Change in the External Appearance of FX5U CPU Modules

April 2022 (Ver. C: July 2023)

FAM-A-0047-C

3.1 Dimensions of Opening of the Connector for Built-in Ethernet Communication

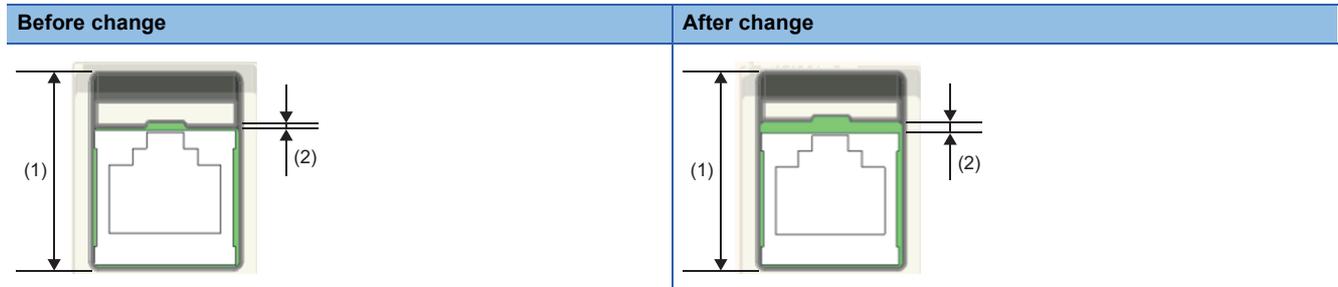
The dimensions of opening of the connector for built-in Ethernet communication will be changed.

The dimension of (1) will be extended by 0.5mm.

The dimension of (2) will be extended by 1mm.

FX5U-32□

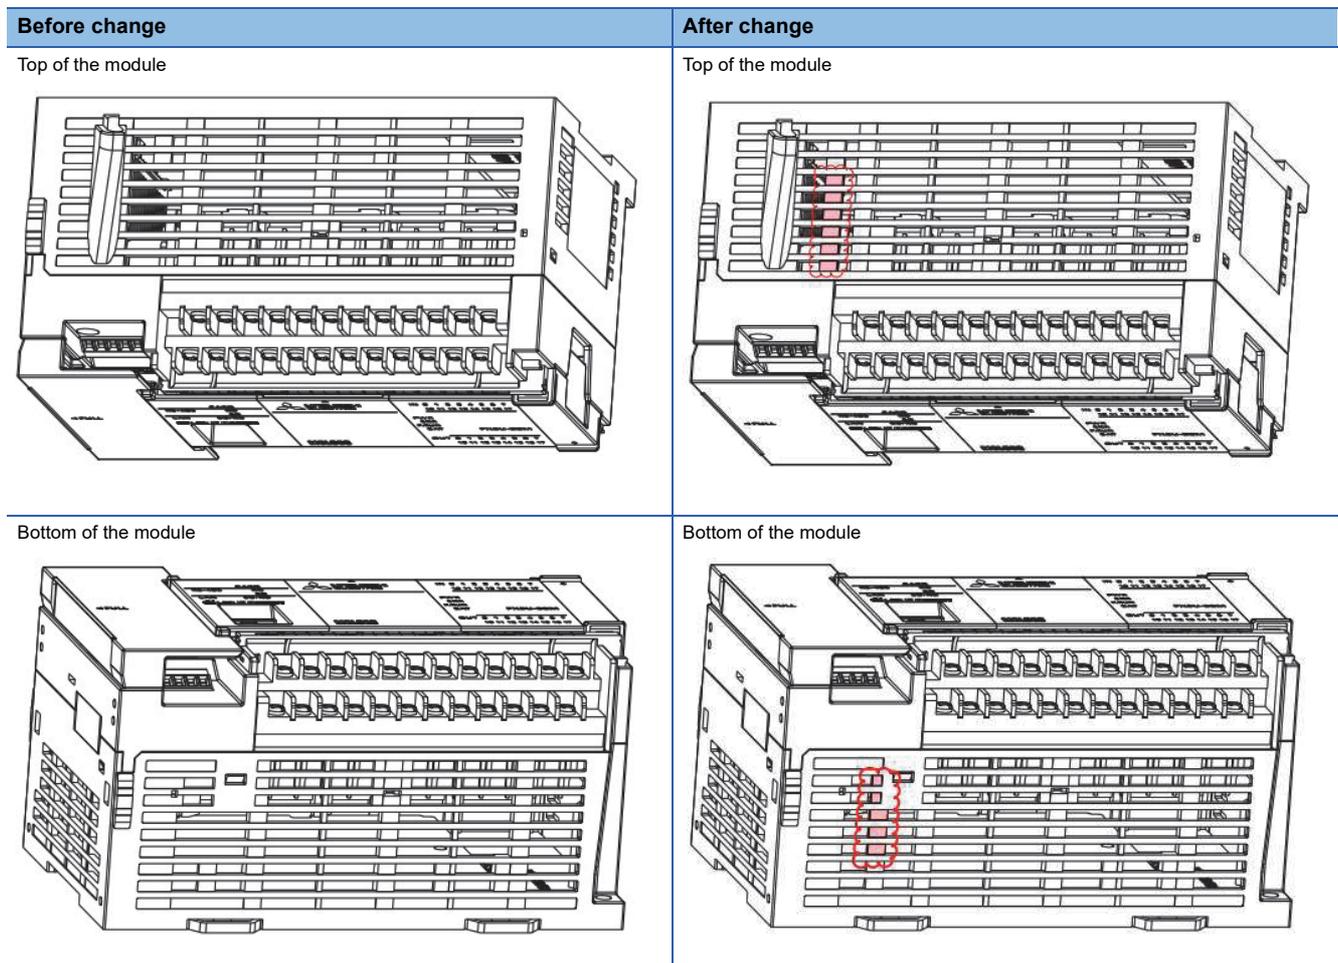
Shape for connection is added to the slits on the module case for the X5U-32□; one place on the top surface and one place on the bottom surface.

FX5U-64□

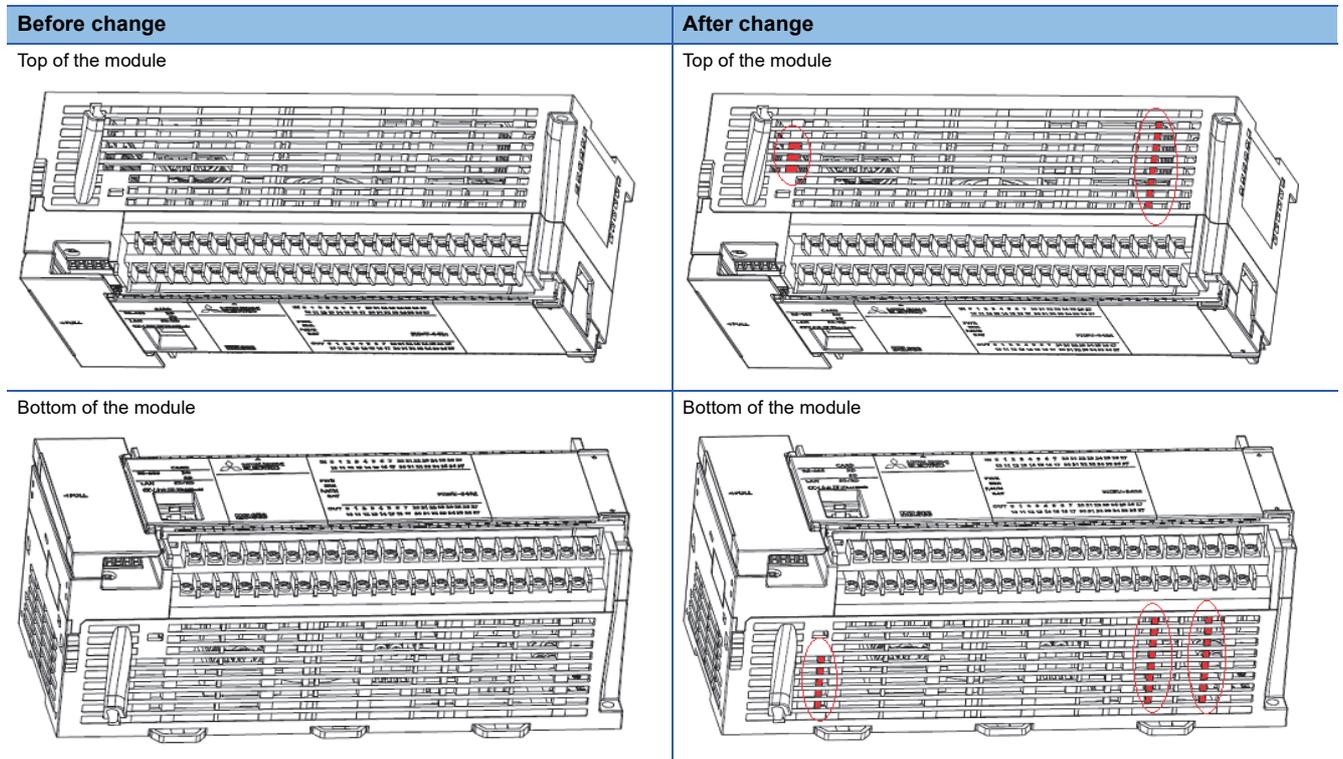
Shape for connection is added to the slits on the module case for the FX5U-64□; two places on the top surface and three places on the bottom surface.

FX5U-80□

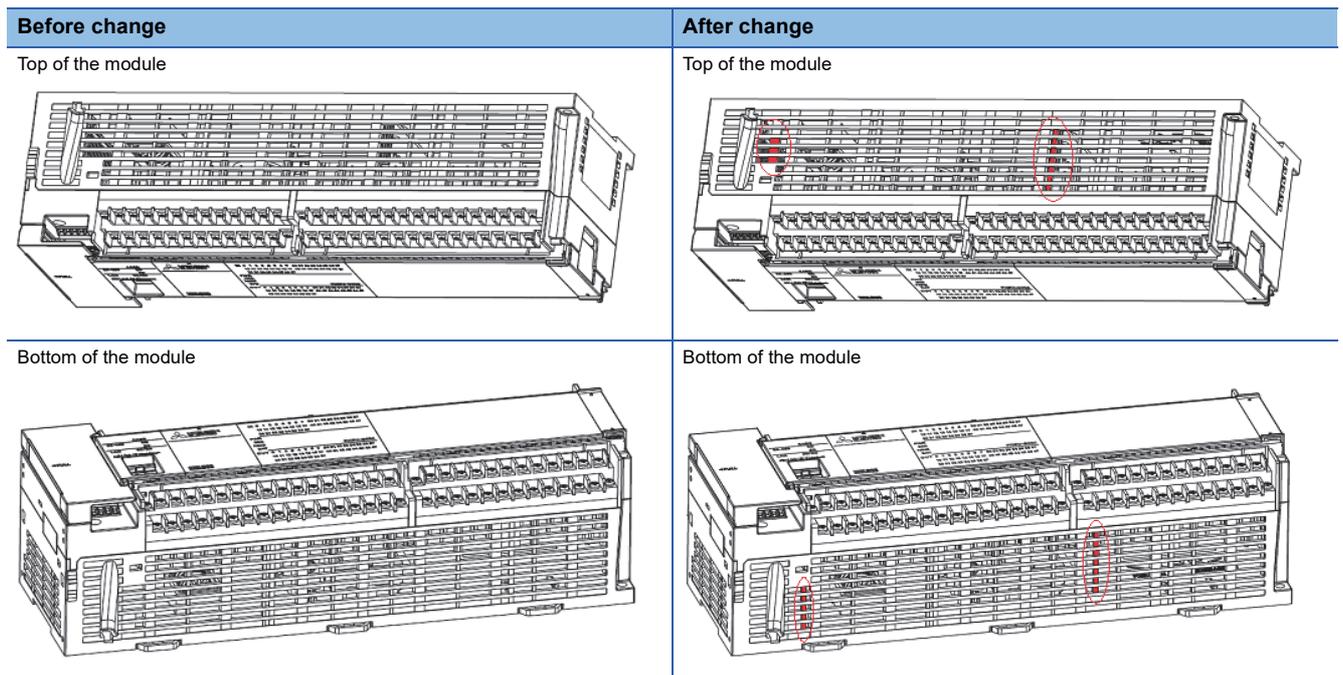
Shape for connection is added to the slits on the module case for the FX5U-80□; two places on the top surface and two places on the bottom surface.

3.3 Two-dimensional Code for Parts Management

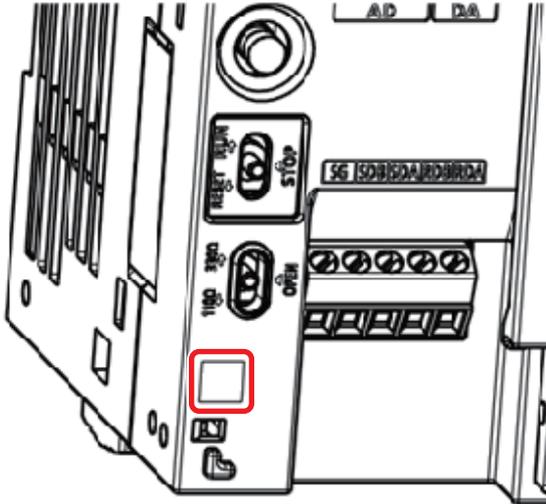
A two-dimensional code for parts management will be added on the cover.
